REGIONAL REVIEW NOTIFICATION

ARC REVIEW CODE: R1712062

Name of Proposal: 30 Ted Turner Drive (DRI 2758) <u>Review Type</u>: Development of Regional Impact (DRI) <u>Submitting Local Government</u>: City of Atlanta <u>Date Opened</u>: December 6, 2017 <u>Deadline for Comments</u>: December 21, 2017 by 5:00 PM <u>Date to Close</u>: December 26, 2017*

30 TED TURNER DRIVE DRI City of Atlanta Natural Resources Division Review Comments

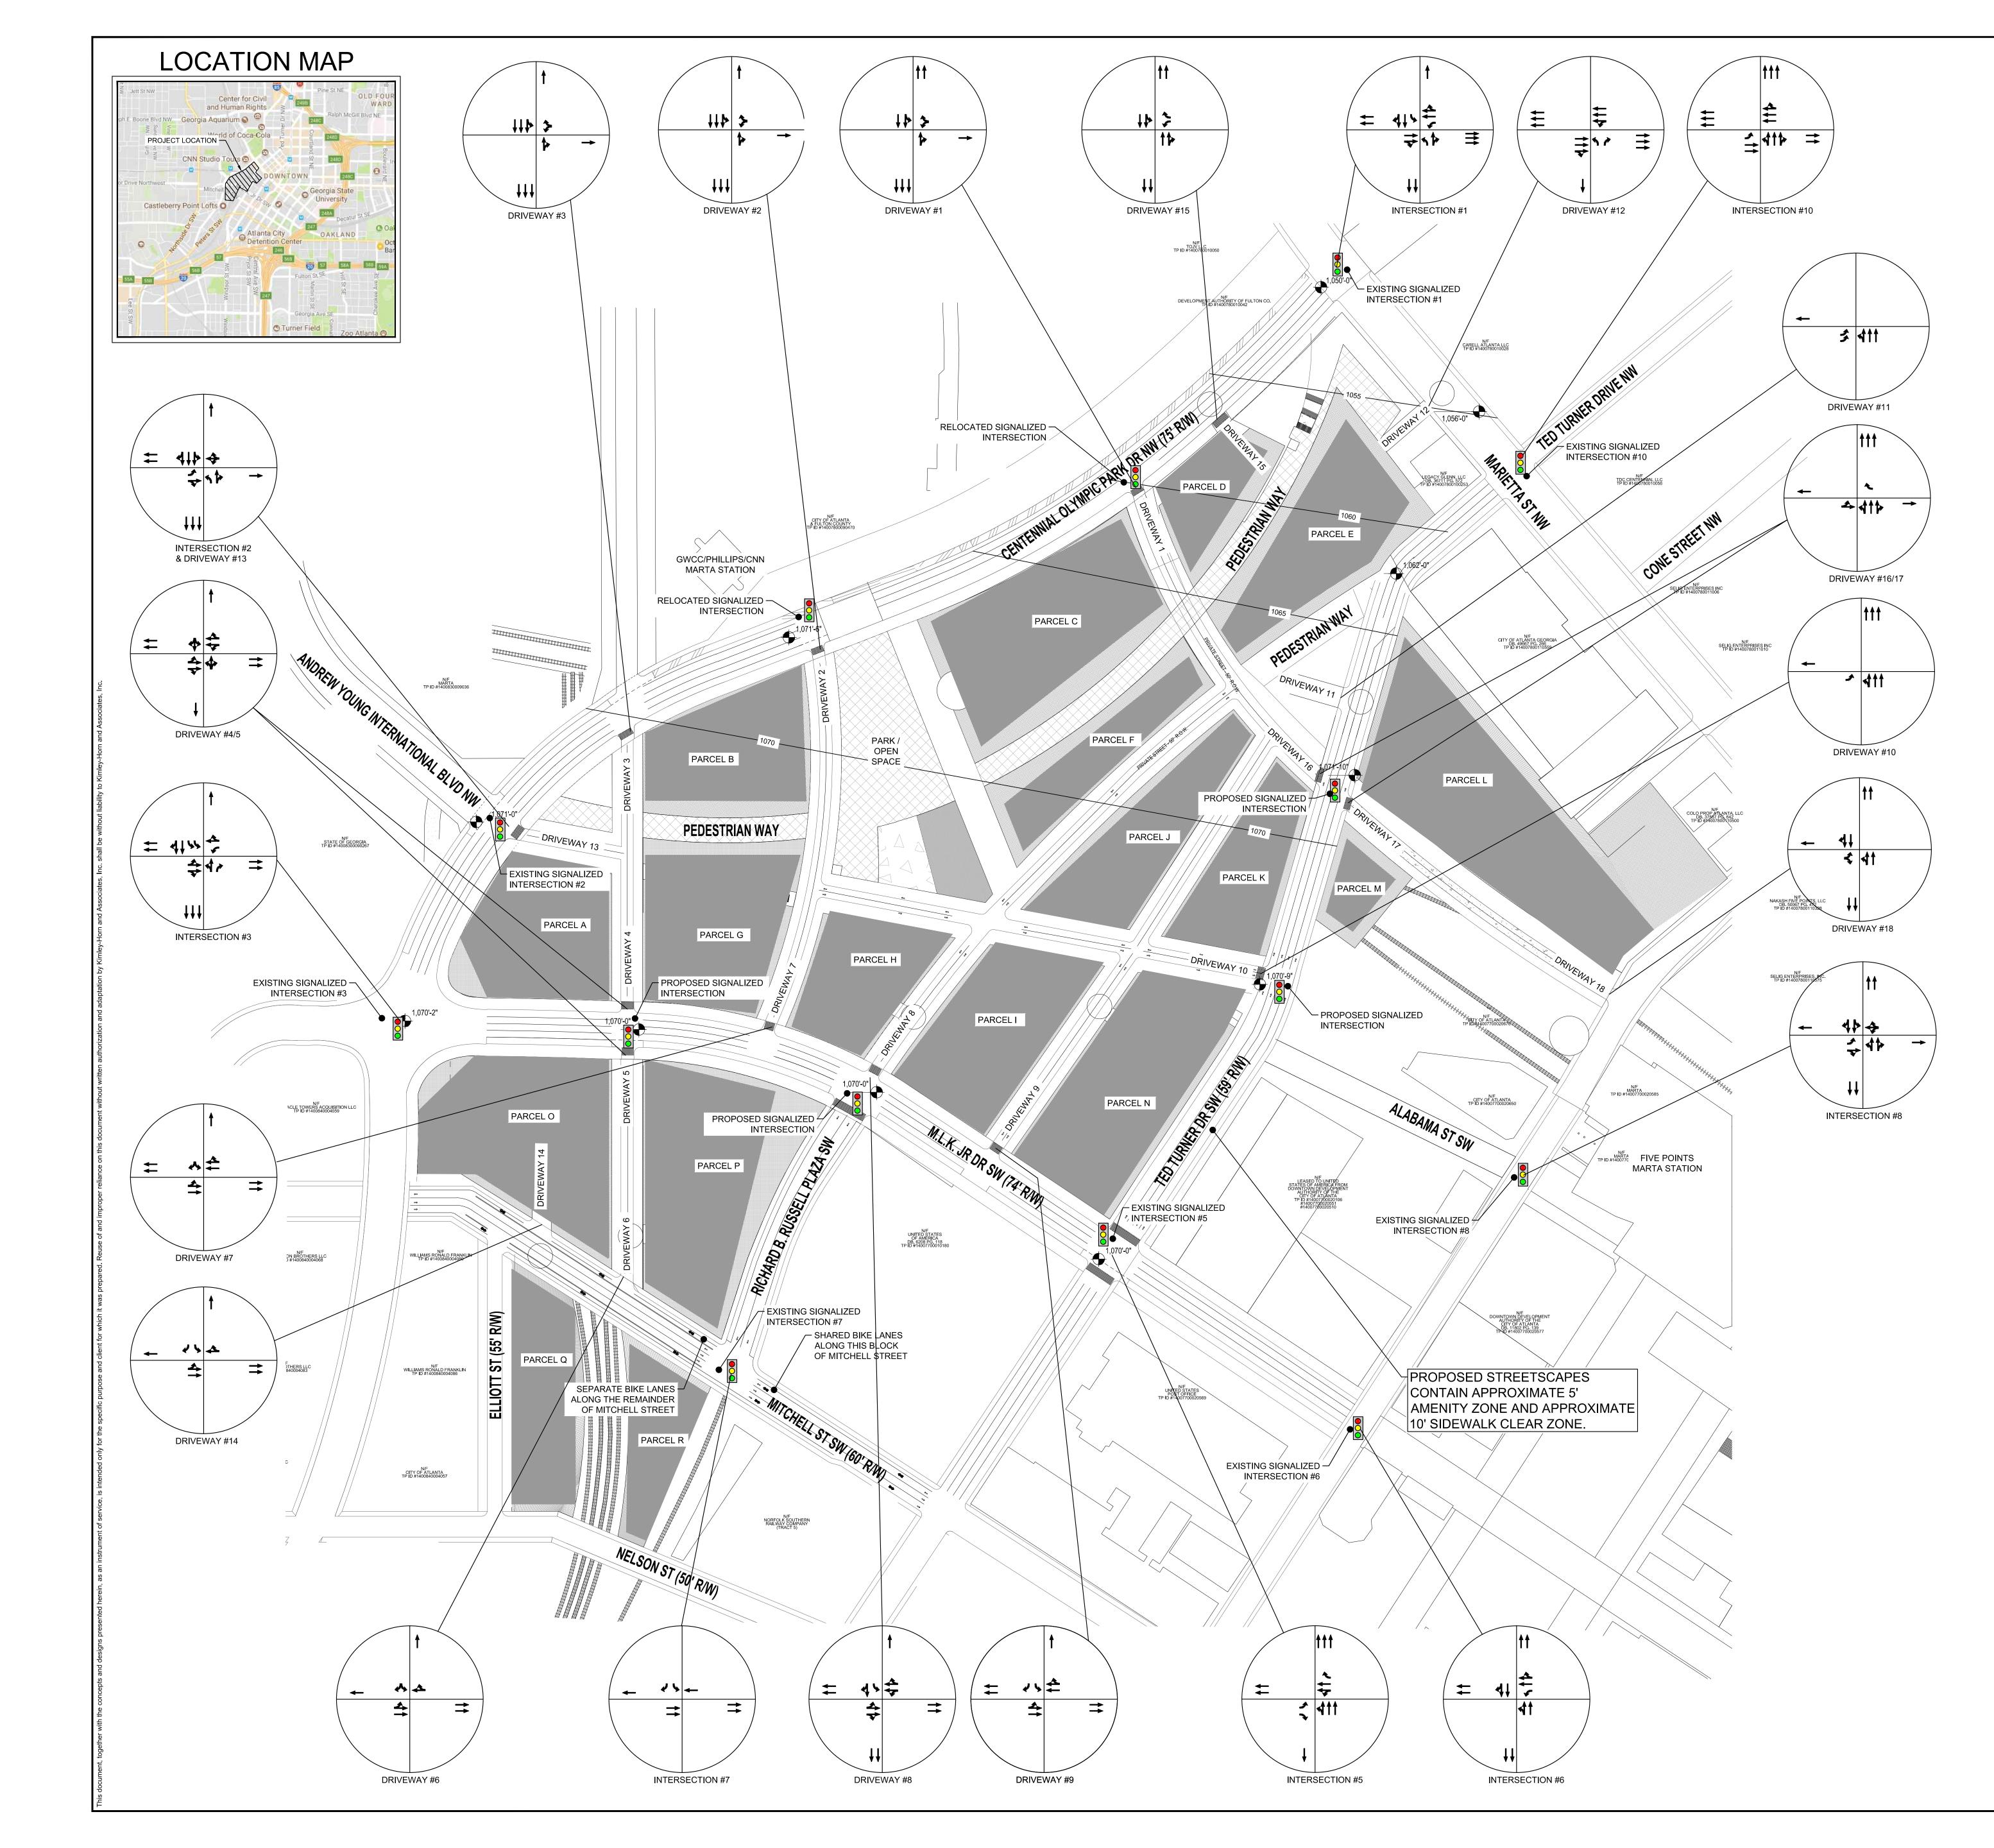
Pedestrian facilities are currently available along existing roadways allowing for safe accessibility. The site plan does not provide information regarding pedestrian and bicycle facilities.

The site plan does not provide specific information or depictions of bicycle and pedestrian facilities.
